April 2, 2015

## Announcement of Design Change for DG4V-3 Series

We would like to announce the design change of the DG4V-3 series, as the mold cast of the body has been updated leading to slight change in appearance.

- Design change of the DG4V-3 series solenoid operated directional control valves, due to the update of the body's mold cast.
- The new design number is "56".

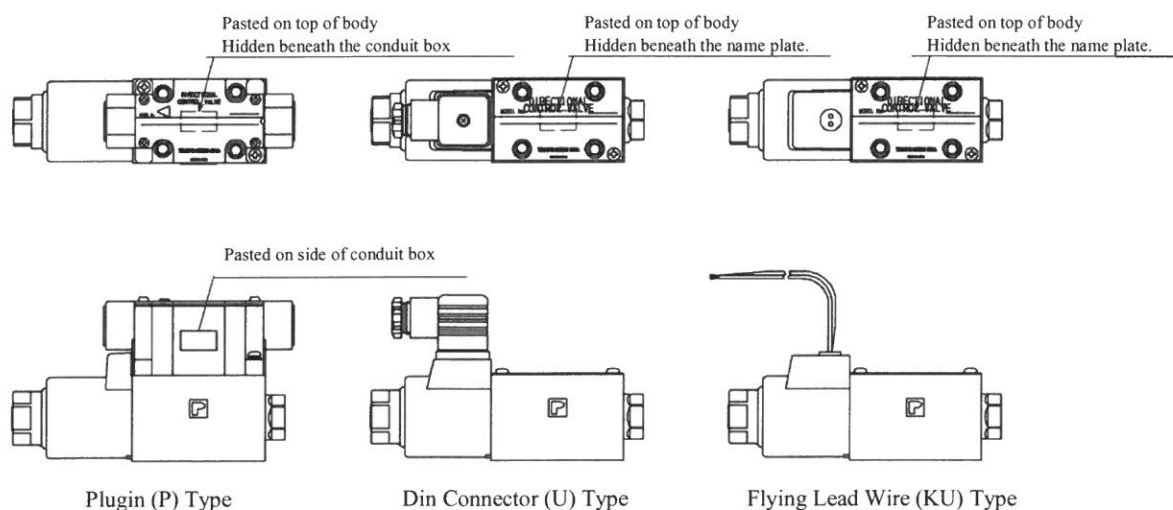
- The previous model had a 6-side finish treatment, but the new 56 design series will have a 4-side finish treatment, leaving the remaining 2 sides with the letter casting with a casting surface. This will result in the body having tolerance of  $\pm 1$  mm against the designed width (47mm). Please secure 5mm or more clearance when setting up valves closely together.

- Due to the change of casting surface, the model sticker will be pasted on the following position.

\* Plug-in (P) Type will have 2 stickers.
